Number: 727-57A0135
Original Issue: February 07, 1975
Revision 4: September 26, 2012
ATA System: 5742

SUBJECT: ATTACH FITTINGS Flight Control - Foreflap Carriage Attachment Inspection And Adjustment

SUBJECT: ATTACH FITTINGS Flight Control - Foreflap Carriage Attachment Inspection And Adjustment

This revision is sent to increase the frequency of the repeat High Frequency Eddy Current (HFEC) inspection of production outboard foreflap carriage attach fittings, make compulsory the installation of the improved outboard foreflap carriage attach fittings, make incorporation of the concurrent service bulletins compulsory, add a general visual inspection and functionality check of the outboard foreflap and to require repeat inspections of the improved outboard foreflap carriage attach fittings.

FIGURE 1: INSPECTION (SHEET 1 OF 2)

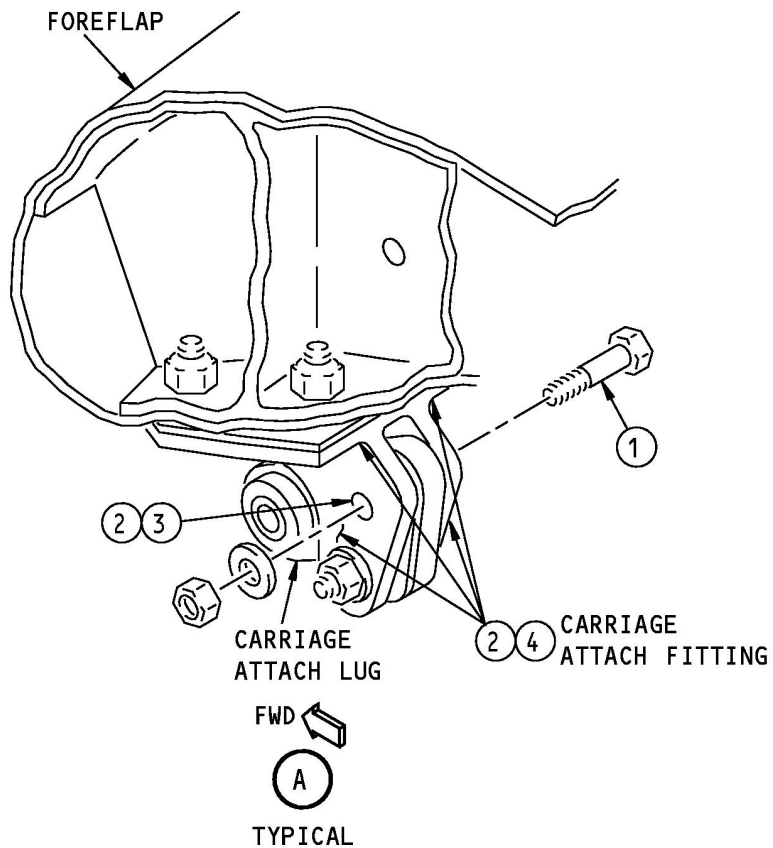
2. Inspect the two carriage attach fittings on the inboard and outboard Foreflaps, of each wing, in accordance with Figure 1.
 - a. If no cracking is found, continue on with Paragraph 3 (note compliance time for this requirement).

- b. If any crack is found, remove the carriage attach fitting from the Foreflap. The Foreflap Sequencing Carriage will first have to be removed. Refer to 727 AMM 27-51-04 (Inboard Flap) and 727 AMM 27-51-14 (Outboard Flap) as an accepted procedure for carriage removal. Then remove the carriage attach fitting. Refer to OHM 57-52-11 (Outboard T.E. Flap) and OHM 57-52-01 (Inboard T.E. Flap) as an accepted procedure. Transfer the mounting holes from the removed carriage attach fitting to its replacement carriage attach fitting (The fittings are unique to their location.).

STEP	TASK	NAME	PROCEDURE	NOTES
1	Remove / Keep	Bolt, Washer, Nut	-	Keep the parts to use again if they are in an approved condition for service.
2	Inspect	Hole, Base Radius, Lug Face, forward edge	Detailed Inspection	Look for any crack or surface deviation on all edges, surfaces and holes. (a)
3	Inspect	Hole	High Frequency Eddy Current	Look for any crack in accordance with 727 NDT Part 6, 51-00-00, Figure 2.
4	Inspect	Hole, Base Radius, Lug Face, forward edge	High Frequency Eddy Current	Look for any crack in accordance with 727 NDT Part 6, 57-40-27, Figure 3.
If there is no crack, reinstall the bolt, washer and nut.				
(a) Nicks, scratches or dents are NOT permitted on the forward surface or in the hole. If found, replace the fitting. The lug surface finish must be 125 microinches or better.

FIGURE 2: CHECK FOR CLEARANCE / INTERFERENCE (SHEET 1 OF 2)

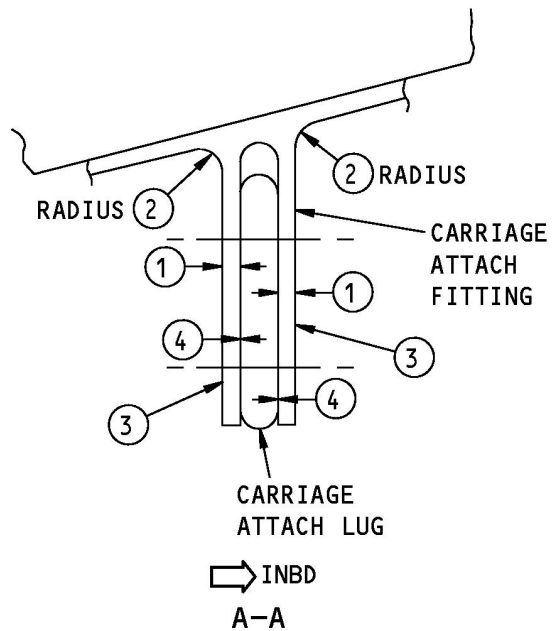
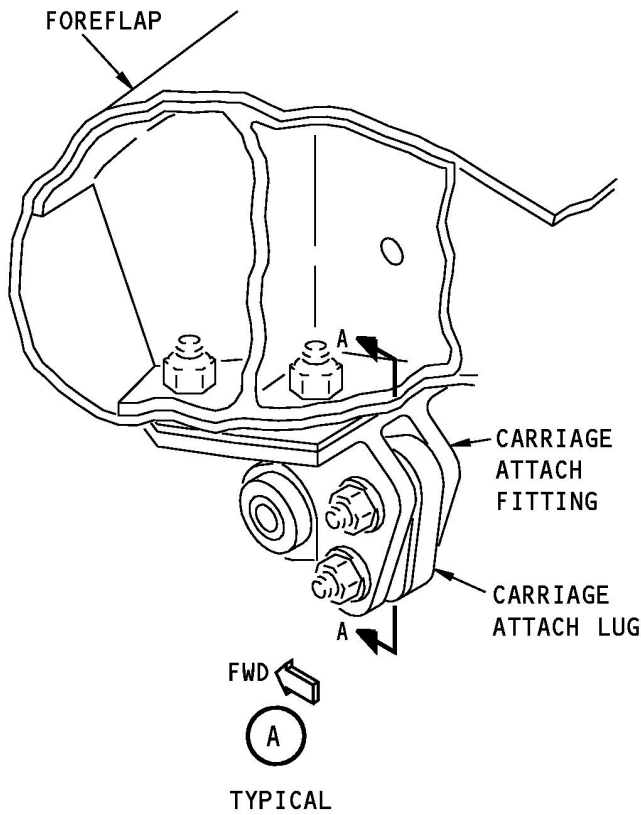
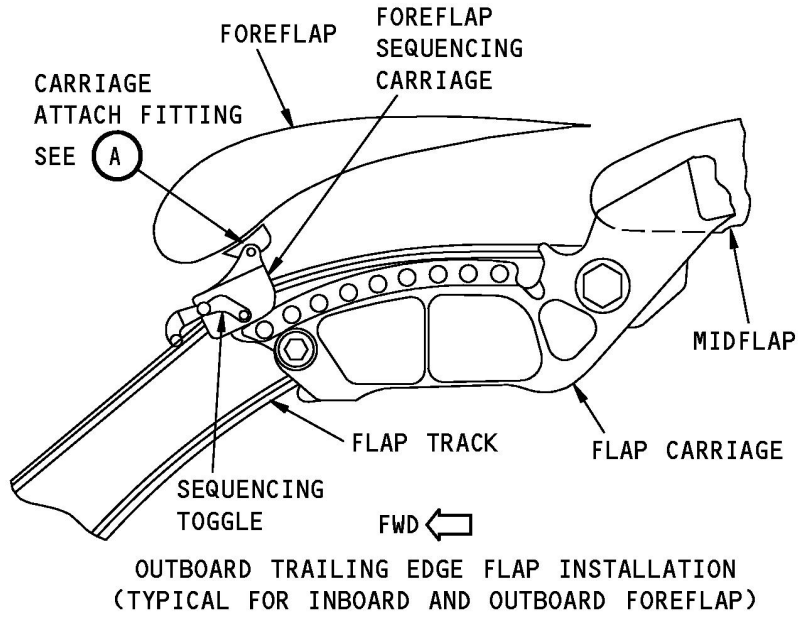
3. Measure the distance between the carriage attach fitting and the carriage lug fitting in accordance with Figure 2.
 - a. If the clearance is between 0.000 inch and 0.003 inch, no more work is necessary. Install the bolt.

- b. If the clearance is more than 0.003 inch, add a shim. Install BACS40R007U015. Remove laminations, as necessary. Apply 2 layers of Primer (BMS 10-11, Type 1) and 1 layer of Enamel (BMS 10-11, Type 2). Refer to SOPM 20-41-02 as an accepted procedure.

FIGURE 3: REWORK OF LUG ASSEMBLY (SHEET 1 OF 3)

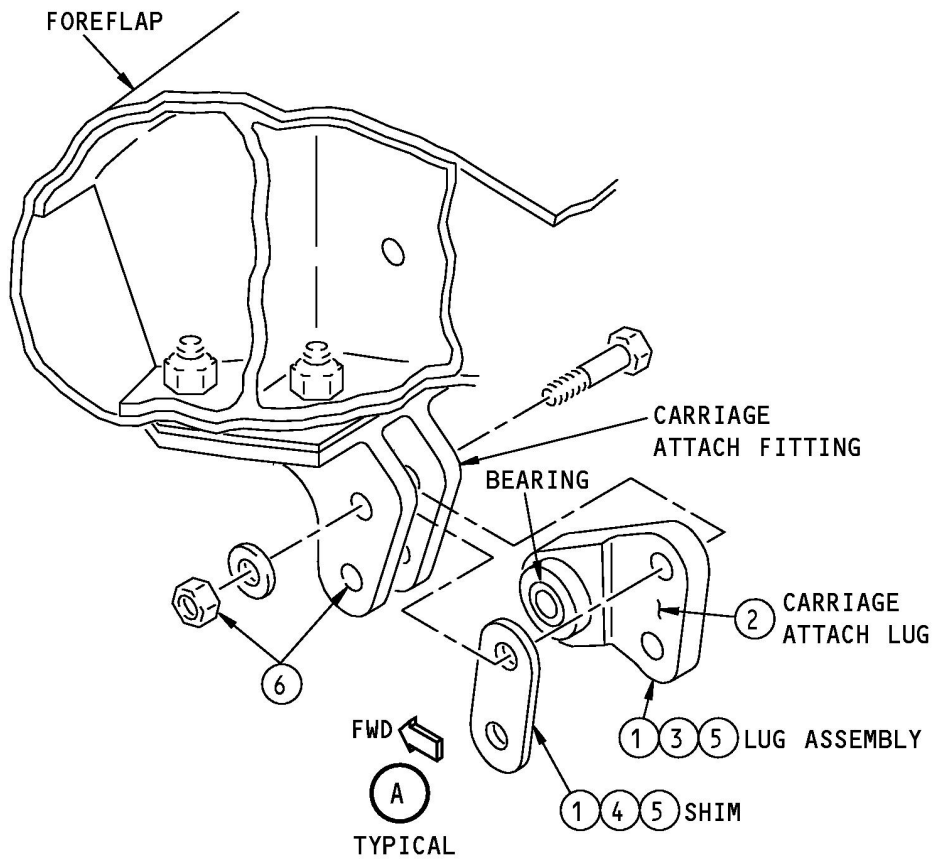
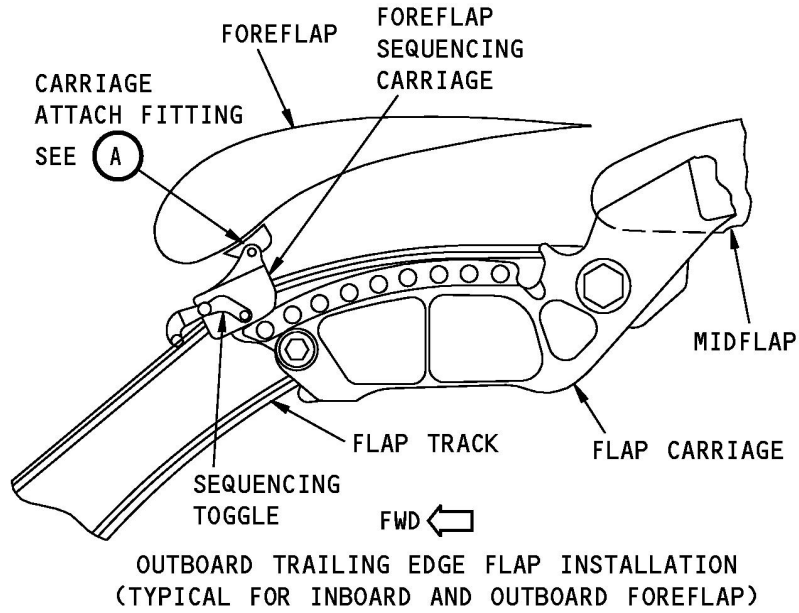
- c. If interference is found, rework the carriage attach lug in accordance with Figure 3.
 4. For the outboard foreflap only, do a general visual inspection and functionality check of the outboard foreflap installation for damage and incorrect operation. Refer to 727 AMM 27-51-14 as an accepted procedure.

STEP	TASK	NAME	PART NUMBER	QTY	NOTES
1	Remove / Keep	Lug Assembly	-	-	In accordance with OHM 57-52-11 (Outboard T.E. Flap) and OHM 57-52-01 (Inboard T.E. Flap). (a)
	Remove / Keep	Shim	-	-	
2	Clean	Lug face	-	-	In accordance with SOPM 20-30-03.
	Sand or Grind		-	-	As necessary for a maximum clearance of 0.003 inch. Hold a surface finish of 125 micro inches or better in accordance with SOPM 20-10-02 and SOPM 20-10-03. (b)
	Inspect	Lug face	-	-	Magnetic Particle Inspection in accordance with SOPM 20-20-01.
	Flap Peen	Lug face	-	-	In accordance with SOPM 20-10-03.
	Apply	Cadmium Plate, Stylus	-	-	To the lug face in accordance with SOPM 20-42-10.
	Inspect	Lug face	-	-	Magnetic Particle Inspection in accordance with SOPM 20-20-01.
	Apply	Primer	BMS 10-11, Type 1	-	One layer of each on the lug face in accordance with SOPM 20-41-02.
	Apply	Enamel	BMS 10-11, Type 2	-	
3	Put / Hold / Align	Lug Assembly	69-26258 (d) -or- 69-30160 (c)	1	In accordance with OHM 57-52-11 (Outboard T.E. Flap) and OHM 57-52-01 (Inboard T.E. Flap) for correct fasteners.

STEP	TASK	NAME	PART NUMBER	QTY	NOTES
5	Install / Kept	Lug Assembly	-	1	In accordance with OHM 57-52-11 (Outboard T.E. Flap) and OHM 57-52-01 (Inboard T.E. Flap). Shim equally both lug faces where material was removed, if necessary. 0.003 inch maximum gap prior to torquing.
	Install / Kept	Shim	-	1	
6	Install / Kept	Bolt	-	2	In accordance with OHM 57-52-11 (Outboard T.E. Flap) and OHM 57-52-01 (Inboard T.E. Flap).
	Install / Kept	Washer	-	2	
	Install / Kept	Nut	-	2	
(a) The Lug Assembly includes the carriage attach lug and the bearing. Do not remove the bearing. Use the parts again if they are in an approved condition for service.					
(b) Minimum lug thickness is 0.14 inch.					
(c) Inboard Flap.					
(d) Outboard Flap.
